AGENDA ITEM REPORT

ITEM: Review and discussion of Site Plan Application by 9201 West LLC to construct a 6 unit, 3- Story Multi-Family Development to be located at 9201 West Bay Harbor Drive. Enclosed are the Site Plans and the Staff Report prepared by Town Planner Michael Miller.

Subject: **Site Development Plan Application**
 Bay Harbor III Townhouses -5 DU Townhouse Complex
 9201 - 9241 West Bay Harbor Drive
 Bay Harbor Islands Acct. No. SPR22-00002
 MMPA Account No. 01-0702-1114

MMPA recommends the Development Review Committee (DRC) **DEFER** action on the proposed Site Development Plan application at this time to allow the applicant's design team to address the listed comments. The submittal package has several design / Code violation issues, some of the plans are inadequate or missing and a few other items need to be corrected.

A-13

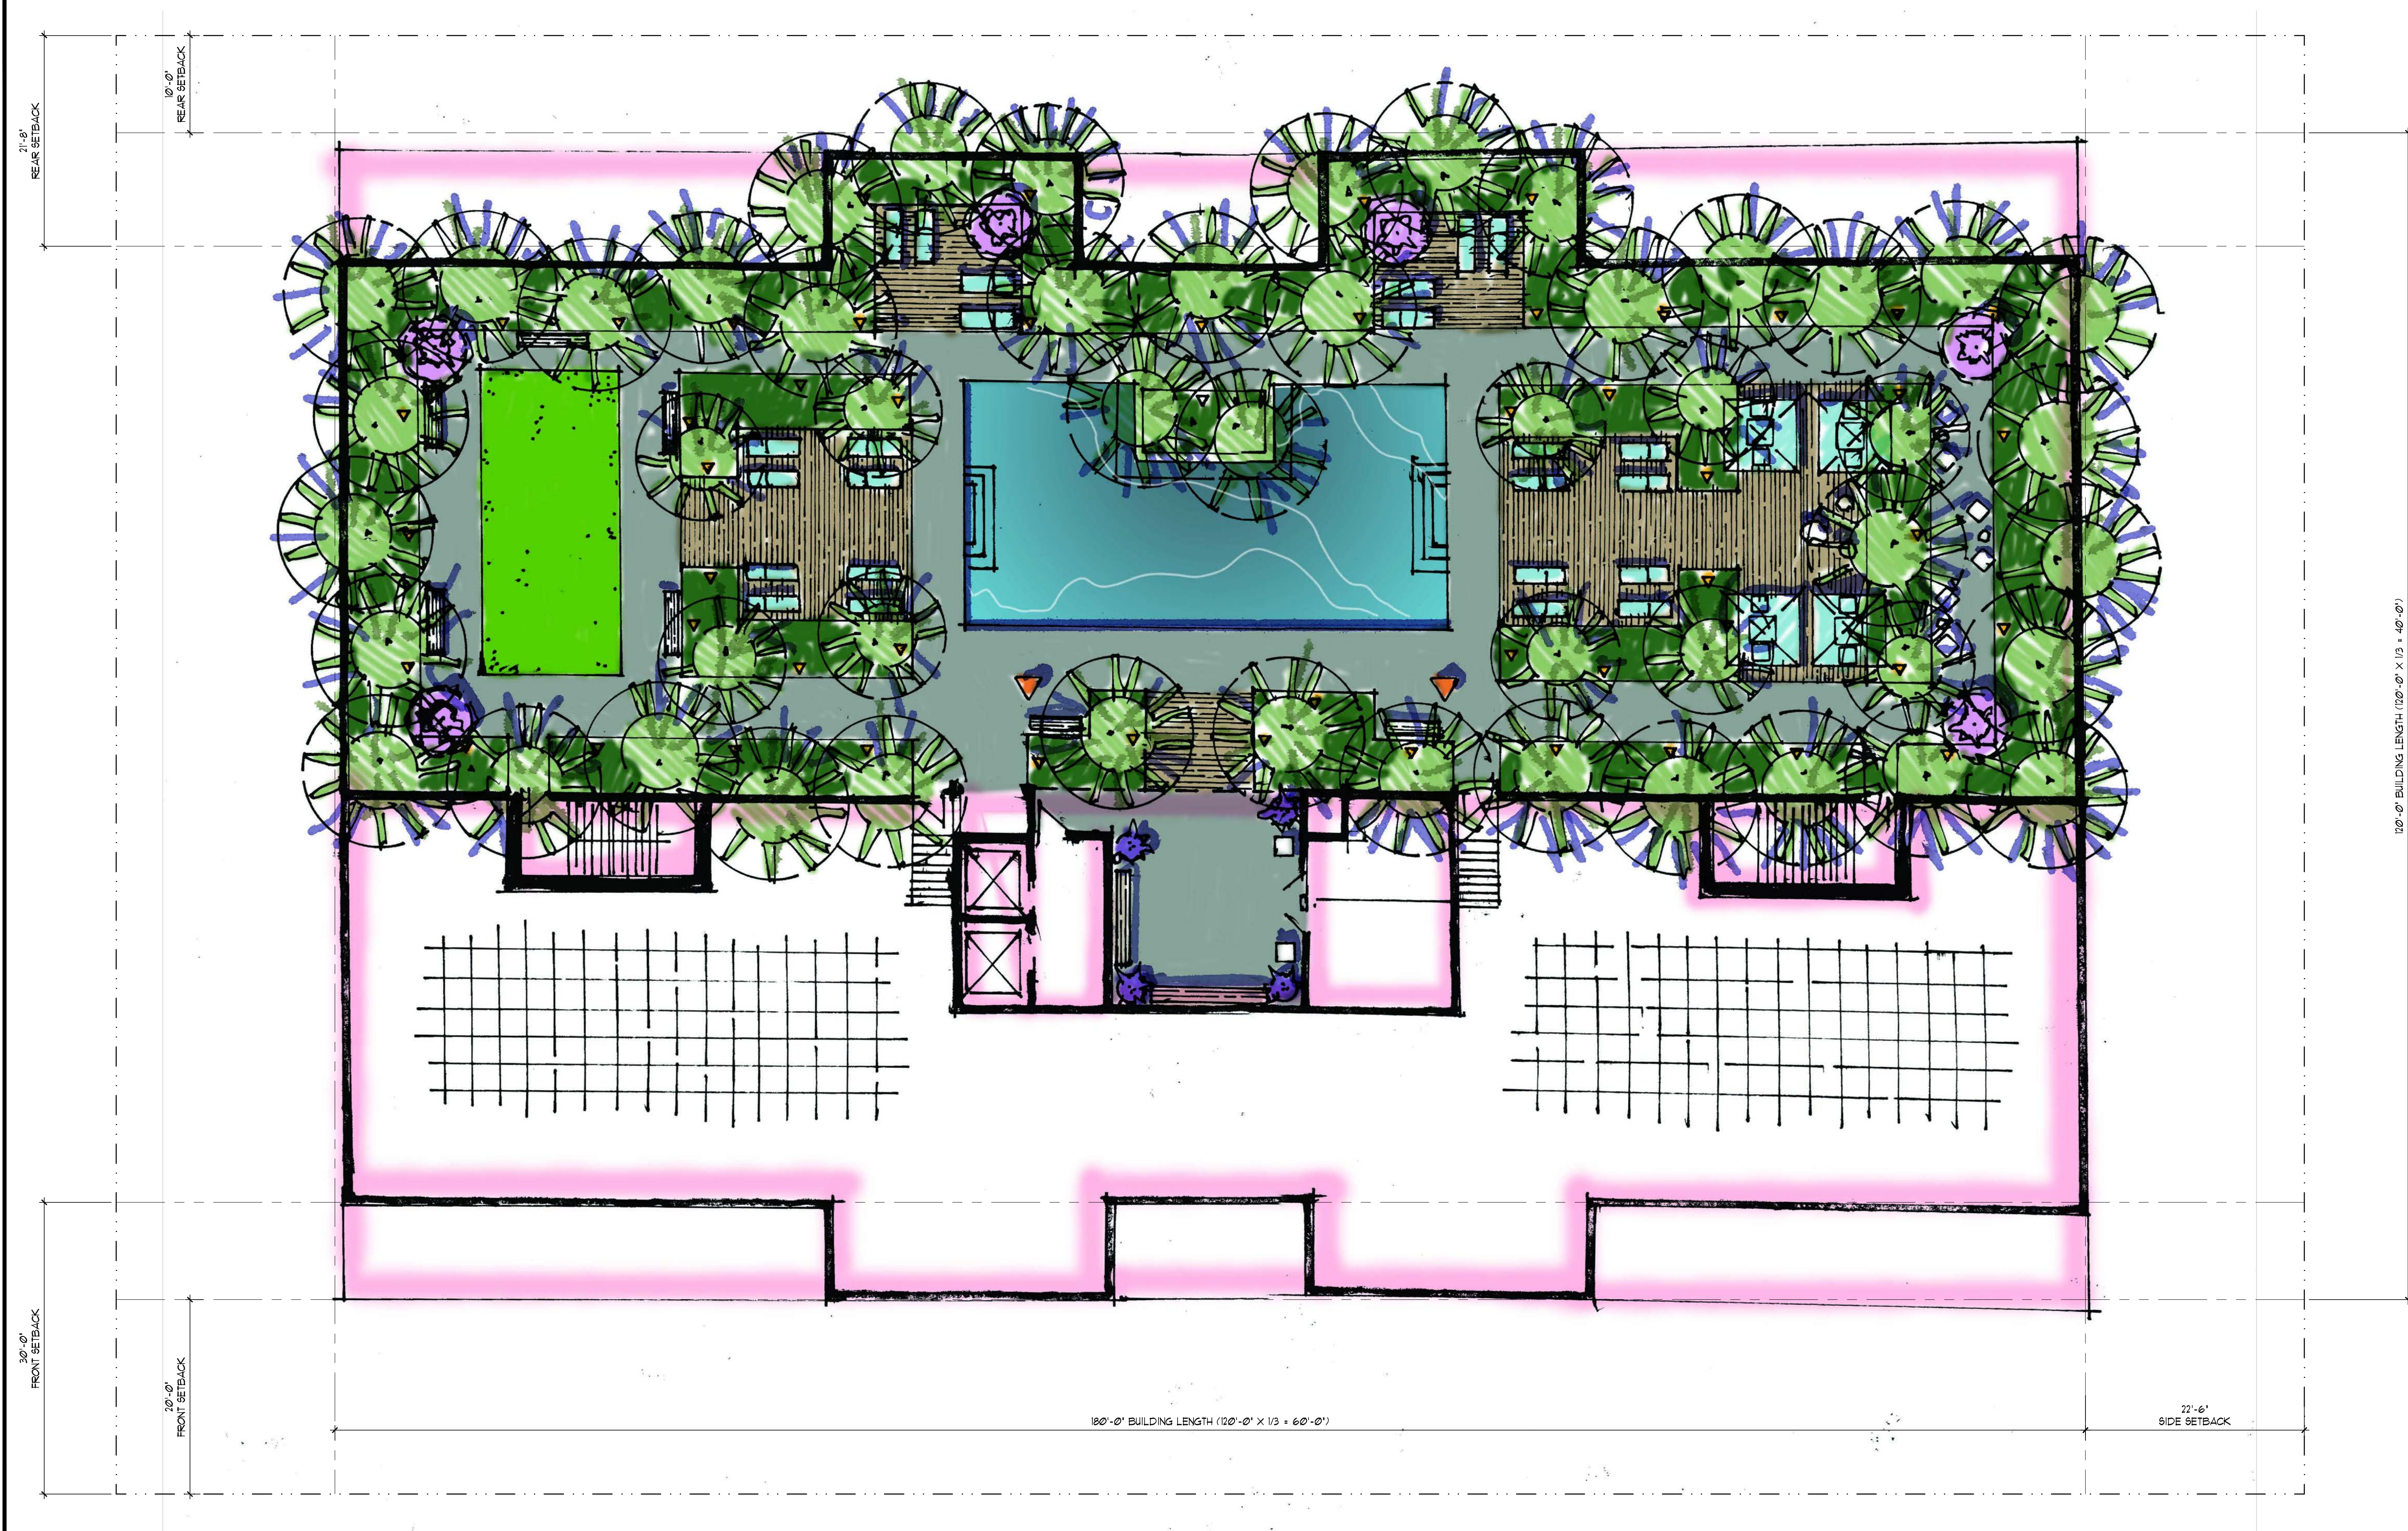
- 6) On Sheet A-12, A-13 / others the plans show several "eyebrows" attached to the building facades extending into the setback areas. Sec. 23-12(15)(e)(v) sets forth the allowable setback encroachment dimensions for such "architectural features". The maximum allowed encroachment is 2' into interior setbacks (side / rear) and 4' into street (and waterfront) setbacks. The plans show 4' eyebrow encroachments into all setbacks. Revise the plans to comply with Code allowances.
